**UNITED STATES  
NUCLEAR REGULATORY COMMISSION**  
WASHINGTON, D.C. 20555-0001

August 25, 2014

**SUBJECT: PEACH BOTTOM ATOMIC POWER STATION, UNITS 2 AND 3 - ISSUANCE  
OF AMENDMENTS RE: EXTENDED POWER UPRATE (TAC NOS. ME9631  
AND ME9632)**

1. Amendment No. 293 to Renewed DPR-44
2. Amendment No. 296 to Renewed DPR-56
3. Non-Proprietary SE
4. Proprietary SE

Figure 3.1.7-1 (page 1 of 1)  
Sodium Pentaborate Solution Temperature Versus Concentration Requirements

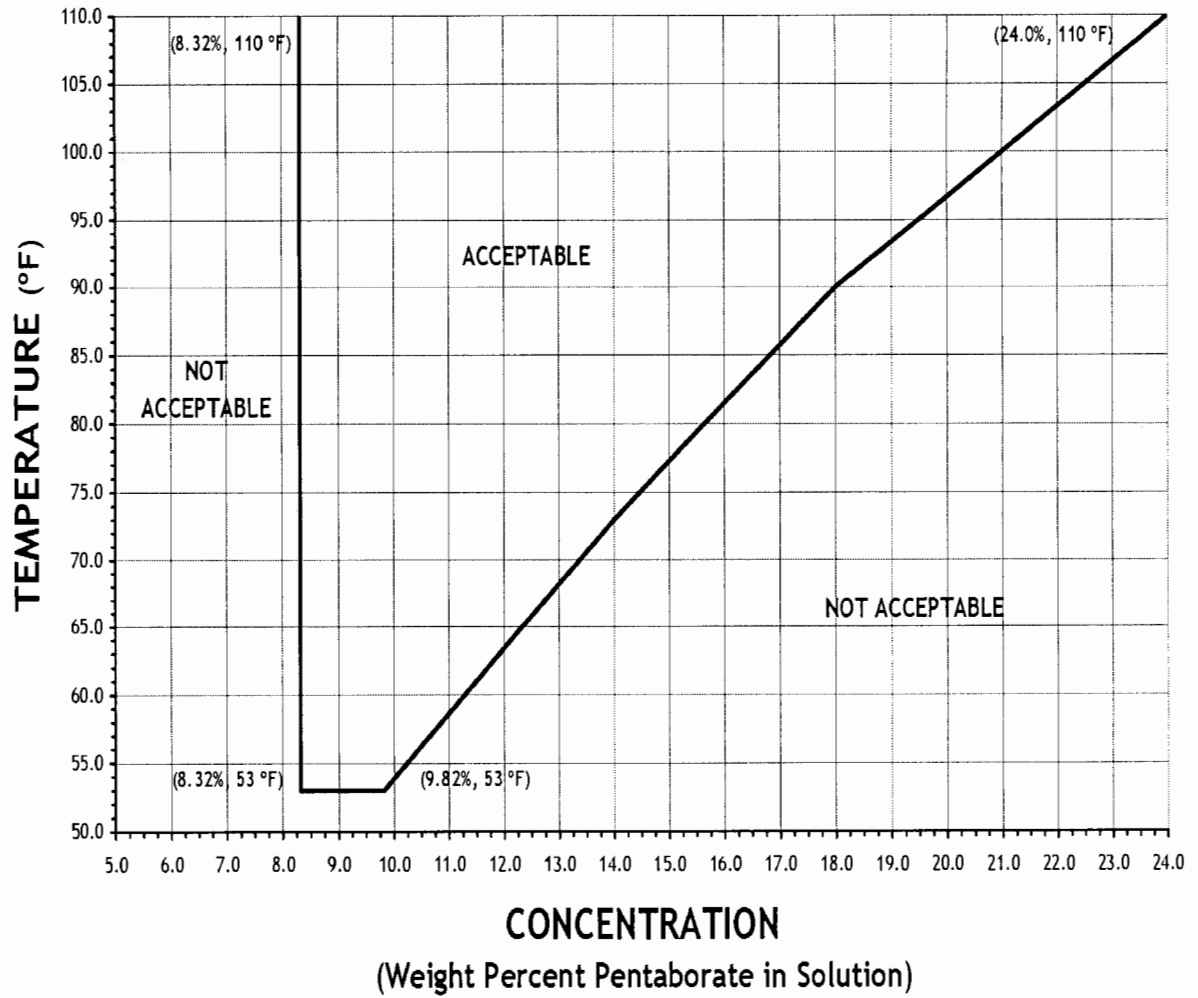
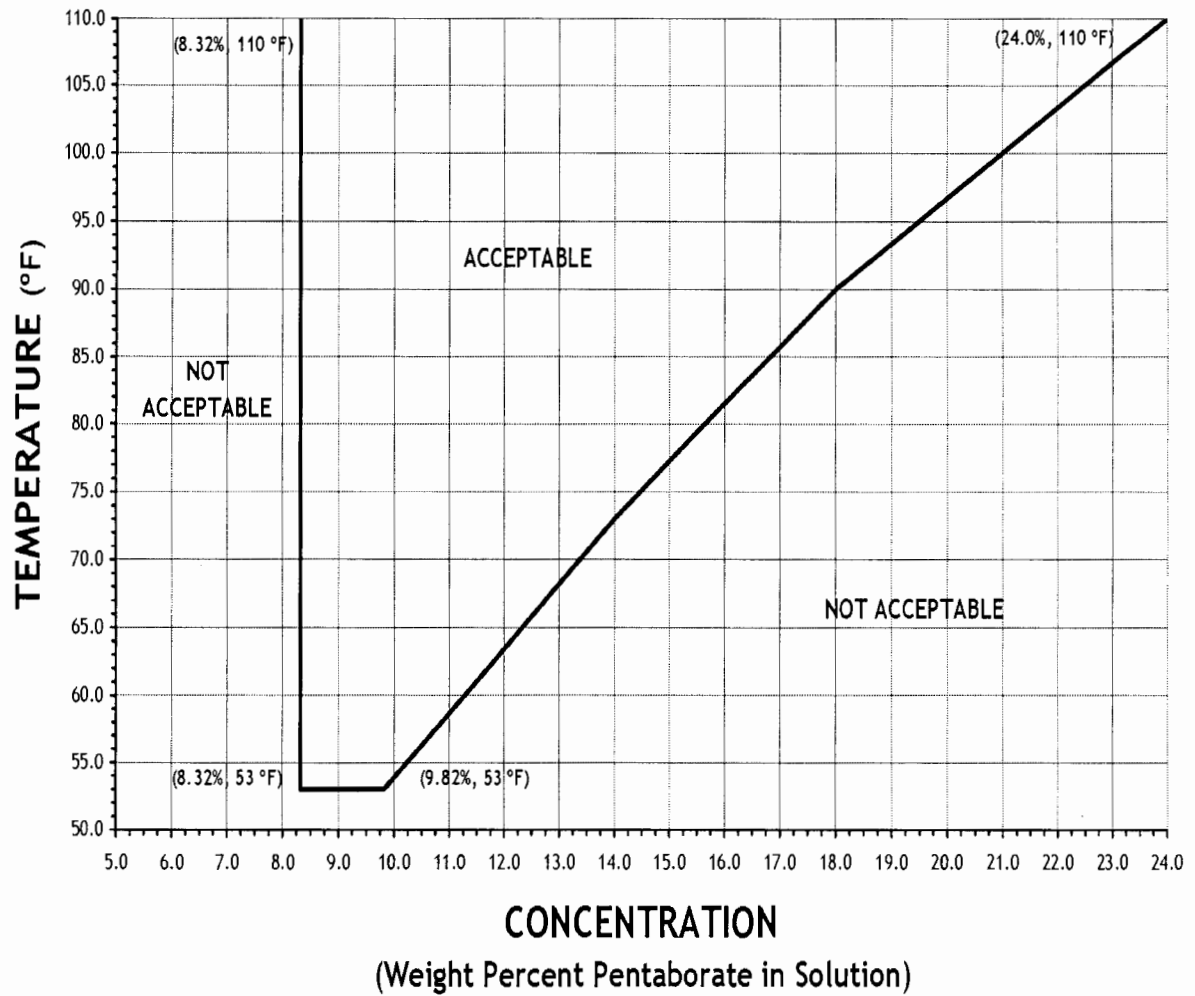
Figure 3.1.7-1 provides a graph of sodium pentaborate solution temperature versus concentration. As discussed in the TS Bases, this figure ensures that a 10 °F margin will be maintained above the saturation temperature so that boron does not precipitate out of solution in the storage tank or in the pump suction piping due to low boron solution temperature (below the saturation temperature for the given concentration). The proposed amendment would revise the figure to show the minimum concentration of  $\geq 8.32\%$  weight that would be incorporated into SR 3.1.7.5 and to more clearly depict the "not acceptable" area for maintaining sodium pentaborate concentrations.

As discussed in Section 3.1.4 of Attachment 1 to the EPU LAR, the equivalency equation in Table 3.1.7.1 would no longer reflect the PBAPS design basis following the EPU. Therefore, the equivalency equation is being replaced (i.e., deletion of Table 3.1.7-1) with specific limits, for EPU conditions, in SR 3.1.7.5, SR 3.1.7.8, SR 3.1.7.10, and Figure 3.1.7-1. The NRC staff finds that the proposed changes will provide clearer direction to the plant operations staff in maintaining the associated SLC system parameters (i.e., versus the current equivalency table

method). In addition, the NRC staff finds that the proposed changes will continue to ensure proper balance of boron concentration, SLC pump flow, and B-10 enrichment consistent with the requirements in 10 CFR 50.62(c)(4). Based on these findings, the NRC staff concludes that the proposed changes to SR 3.1.7.5, SR 3.1.7.8, SR 3.1.7.10, and Figure 3.1.7-1, and the proposed deletion of Table 3.1.7.1 are acceptable.
